## APPLICATION FOR A CERTIFICATE OF APPROPRIATENESS – STAFF REPORT

COA-0003-2020 713 HINSDALE STREET

Nature of Project: Construct rear addition; alter window and opening; remove vinyl siding; remove tree

EXISTING LAYOUT @ 1/4" = 1'0"

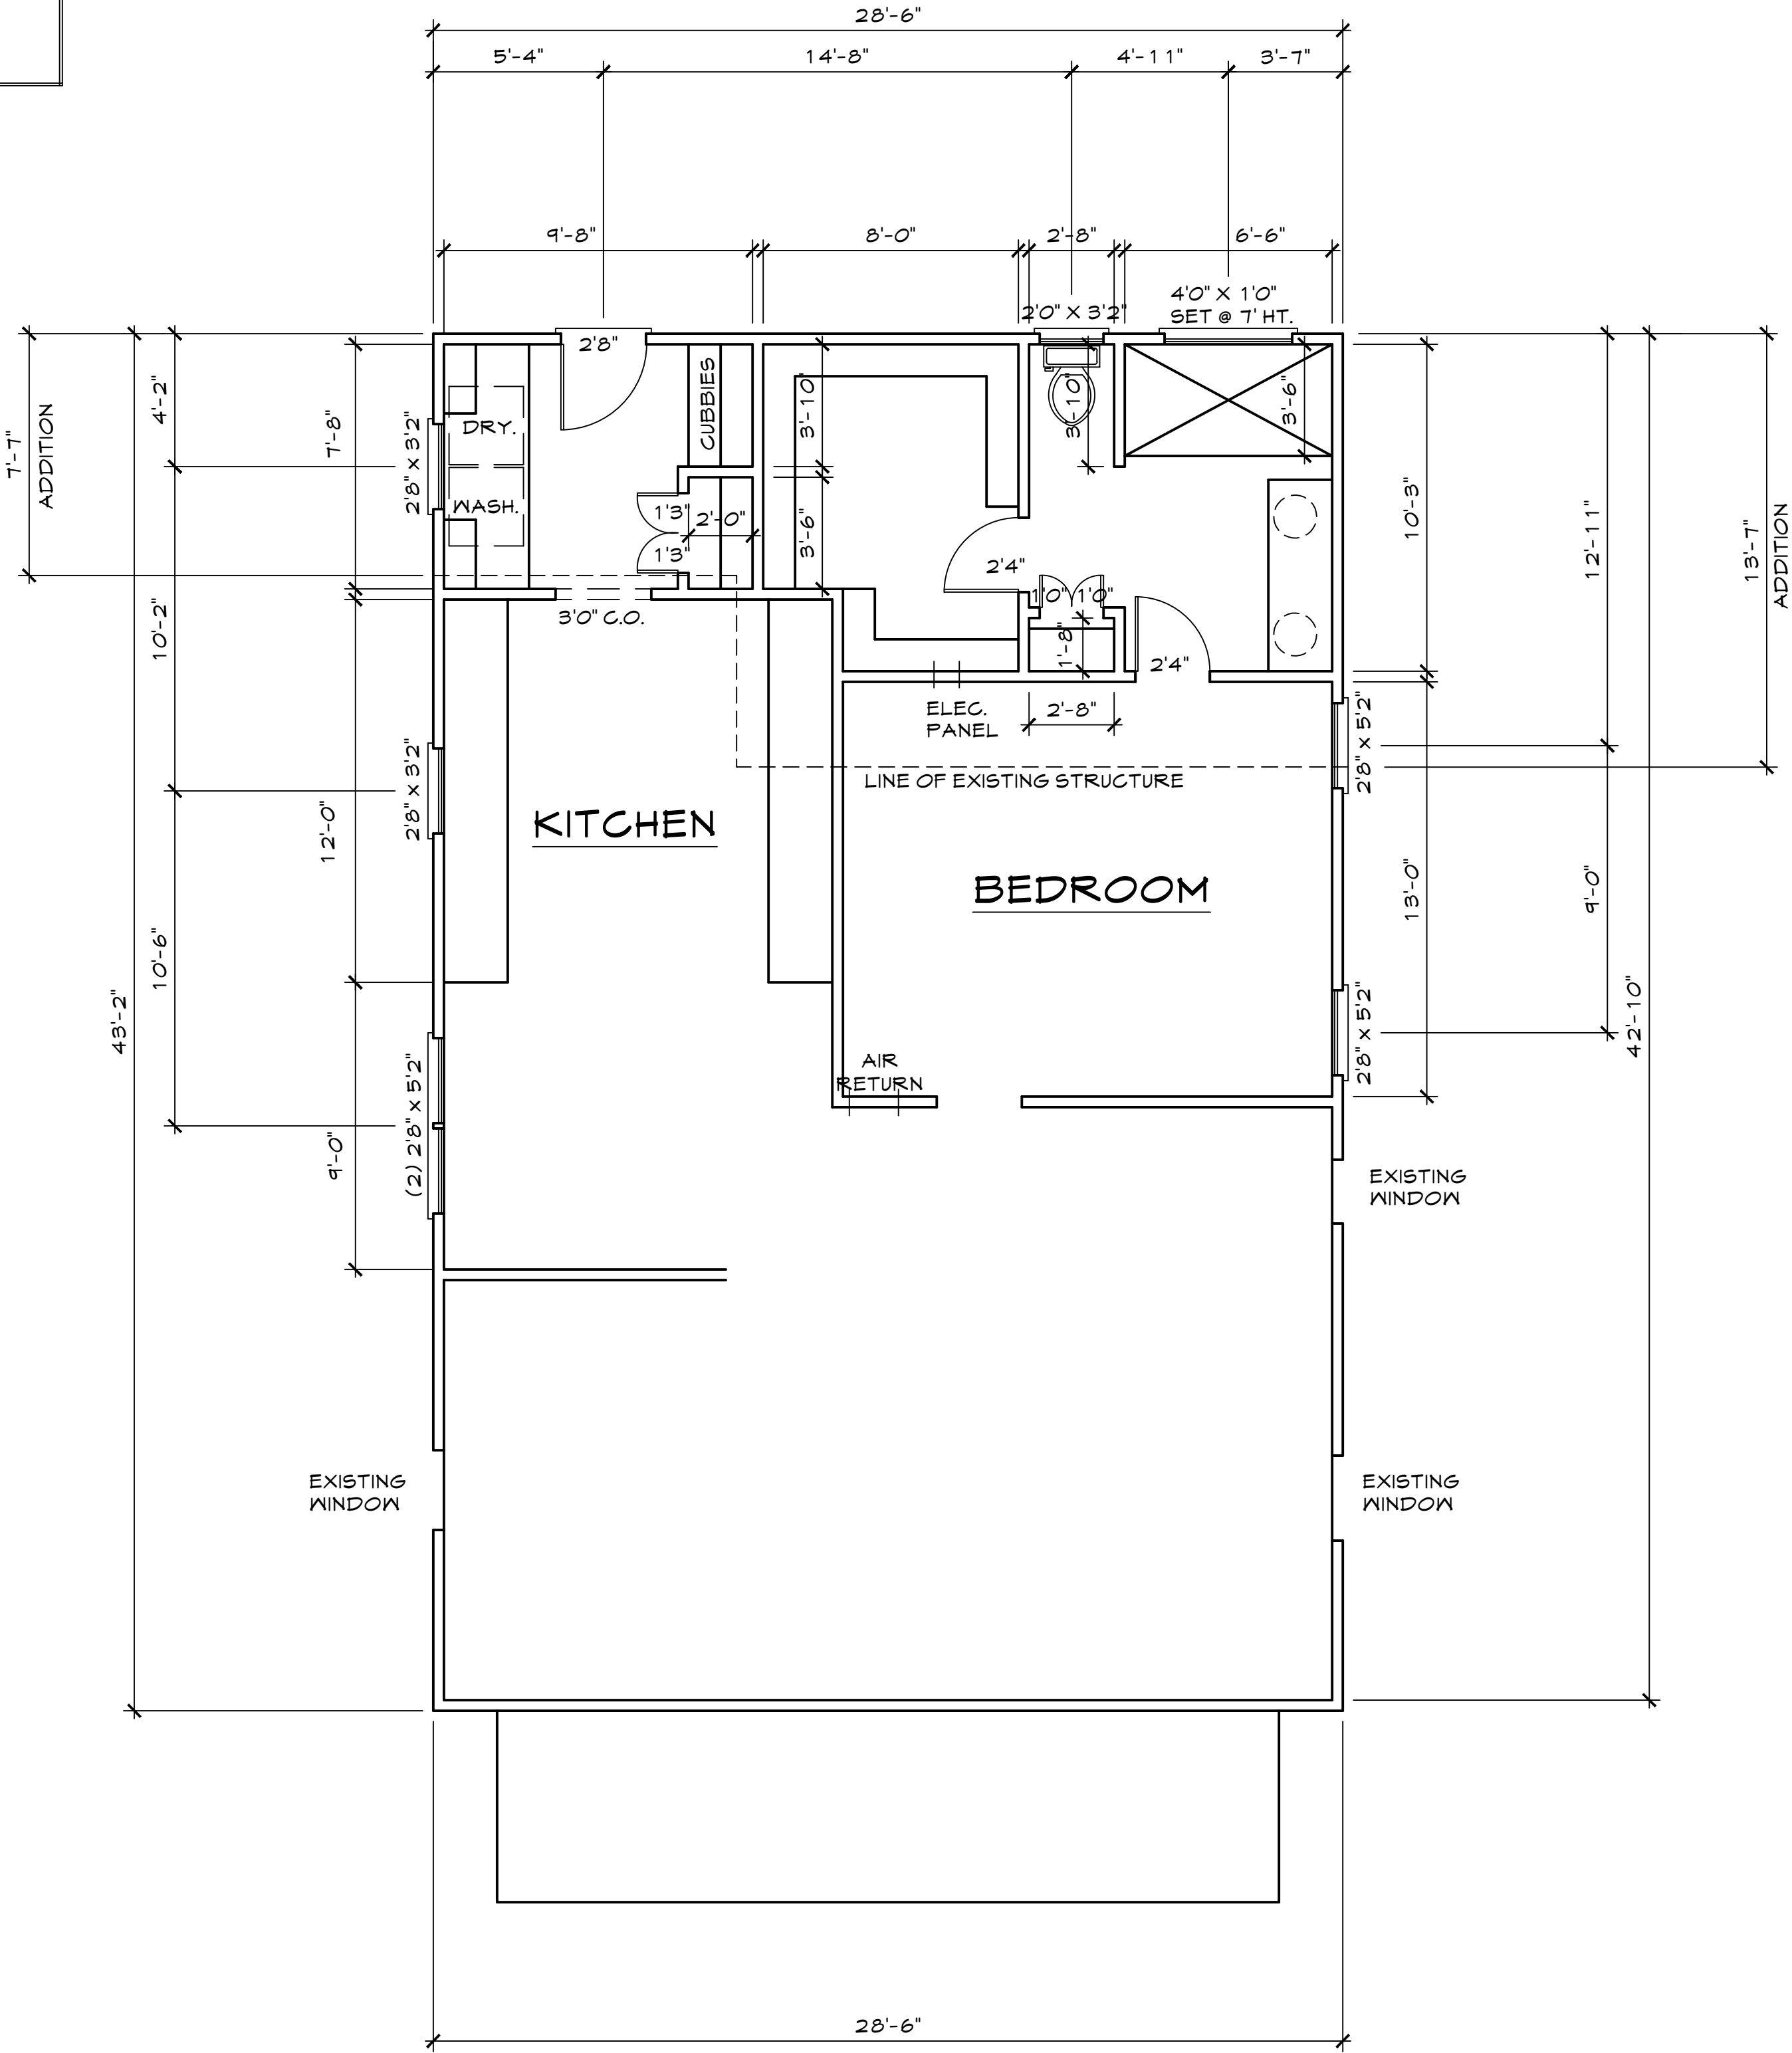
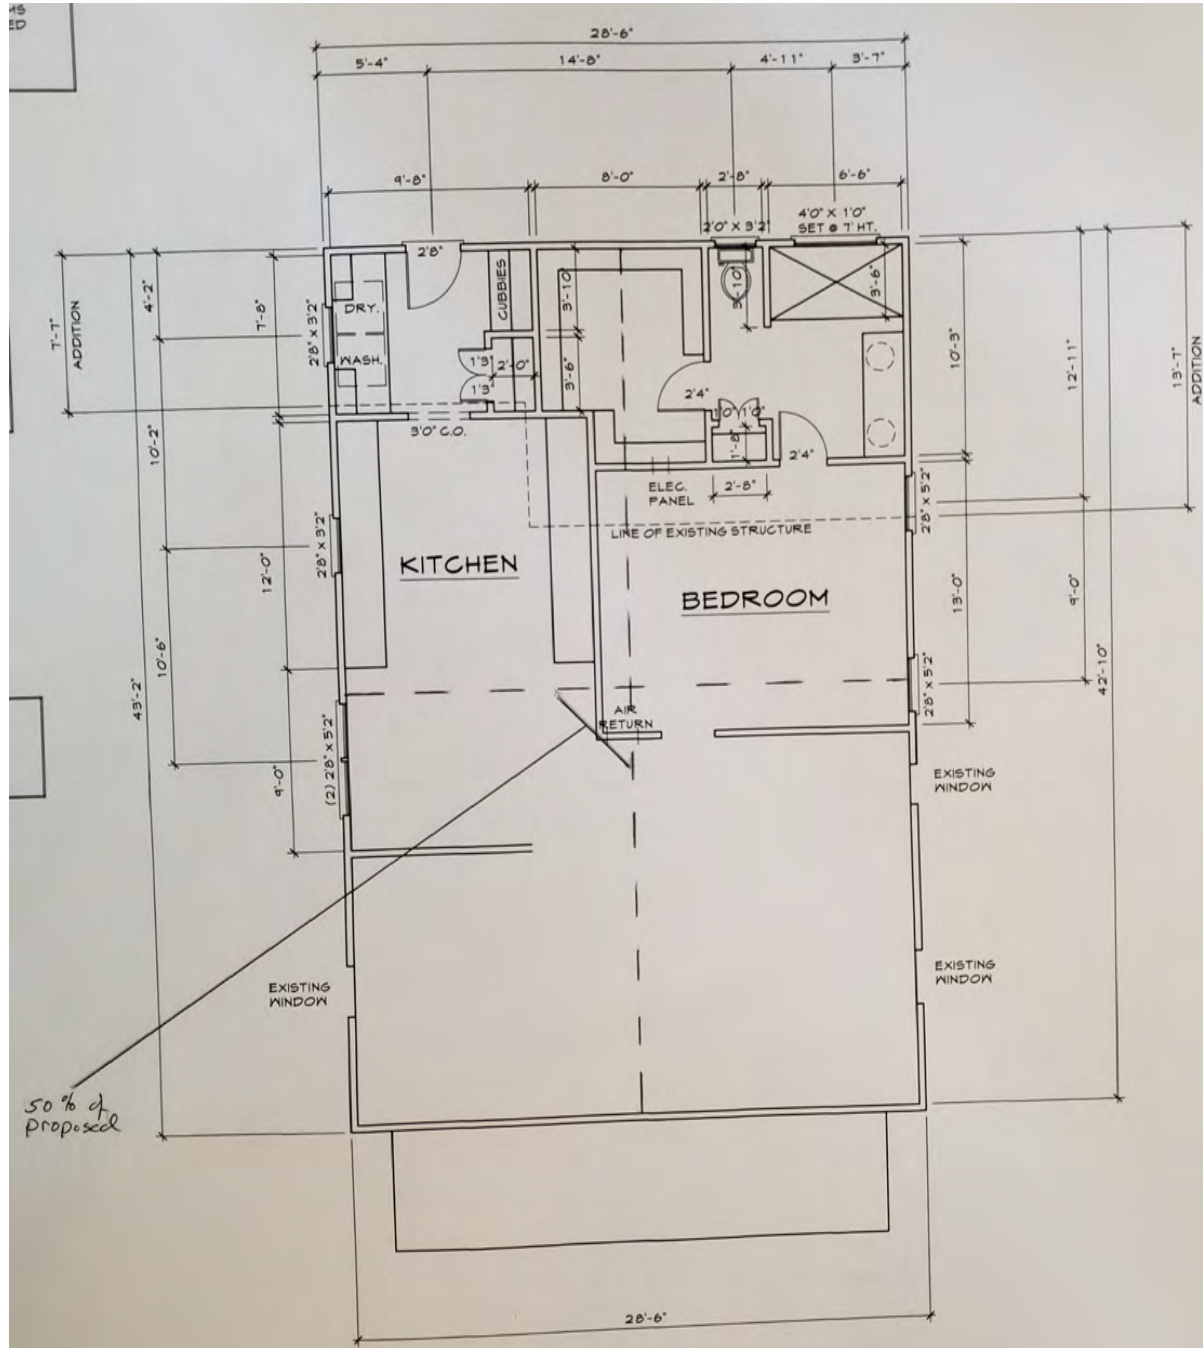
- 4\* The application proposes an addition on the rear, non-character-defining facade of the house.
  - 5\* An existing small rear addition and a rear deck are proposed to be removed to accommodate the new addition that would extend the length of the house as seen from Gaston Street by 10'3". The proposed addition is at the same level as the historic house.

EXISTING LEFT SIDE ELEVATION 1/4" = 1'0"

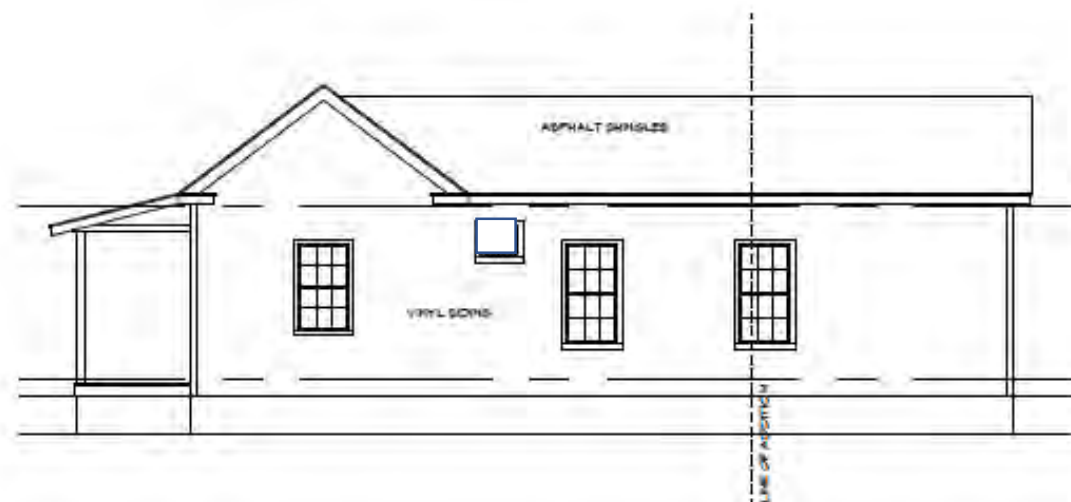
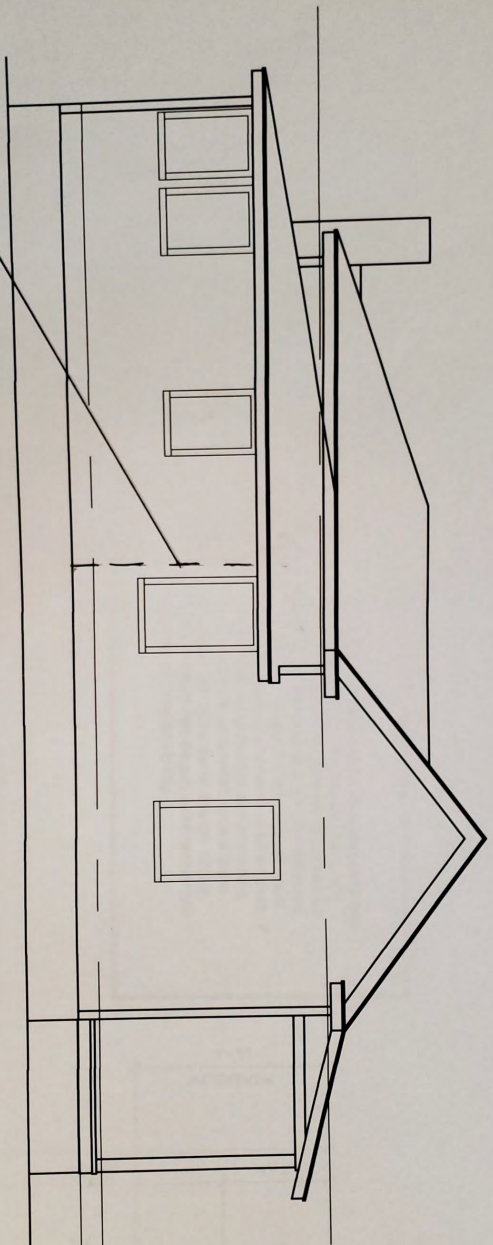
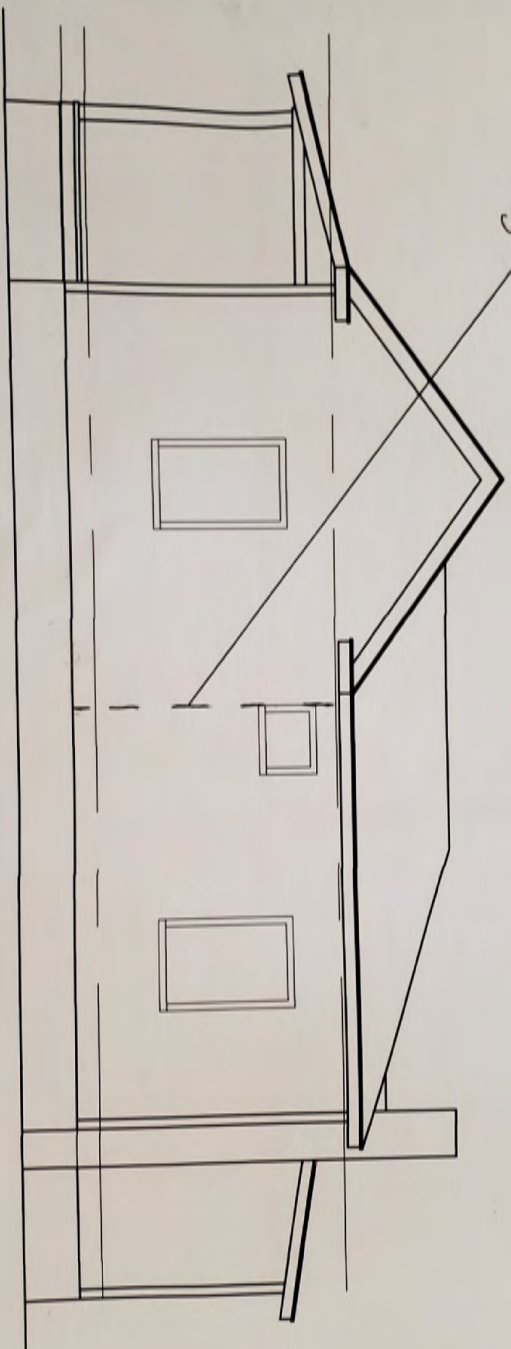
- 7\* As shown in the side elevations, the roof ridge of the addition will be lower in height than the roof ridge height of the historic house. The elevations were not dimensioned, nor was a graphic scale provided.

- c. On the left/west façade, two horizontally oriented six-over-six windows are proposed. The windows of different proportion than the windows on the historic house. This is the only occurrence of that proposed window style on the structure.

- 5\* The applicants propose replacing the existing window with a modern pair of six-over-six vinyl windows without a historic mull separation.

1. That the siding of the addition not be vinyl; that it be either wood or smooth faced fiber cement.
2. That the window opening not be altered.
3. That vinyl windows not be installed in the addition.
4. That details and specifications for the following be provided to and approved by staff prior to issuance of the blue placard:
  - a. Eave detail drawing;
  - b. Window specifications;
5. That details and specifications for the following be provided to and approved by staff prior to installation or construction:
  - a. Specifications for the gutters and downspouts, and location on the building;

NEW REAR ELEVATION 1/4" = 1'0"

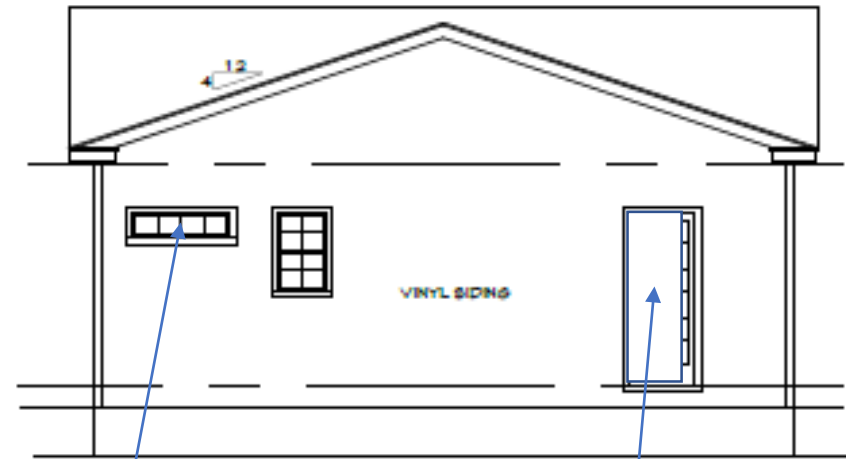
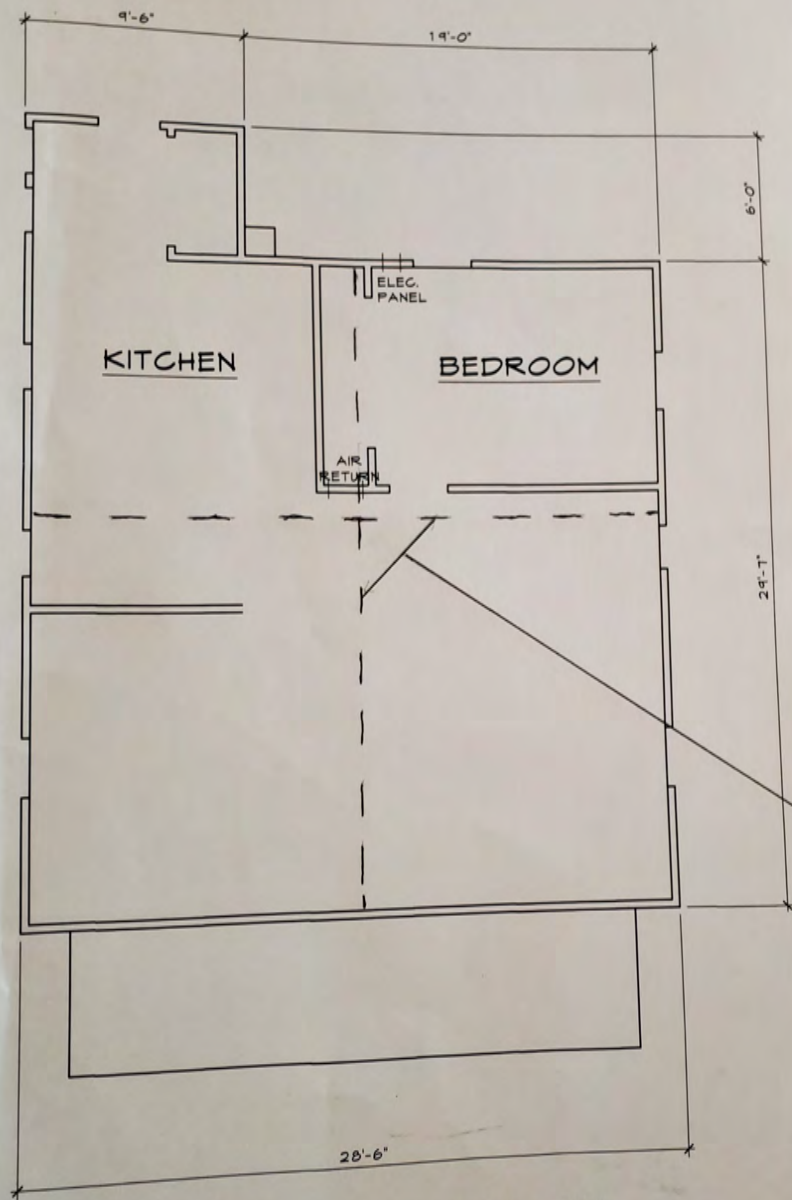
- b. On the rear/south facade, a four-pane transom window is proposed at the rear corner of the property closest to the street. The Committee has not found the installation of these windows to be congruous on character defining facades. One four-over-four window is proposed adjacent to the transom window. This is the only occurrence of both proposed window styles on the structure.
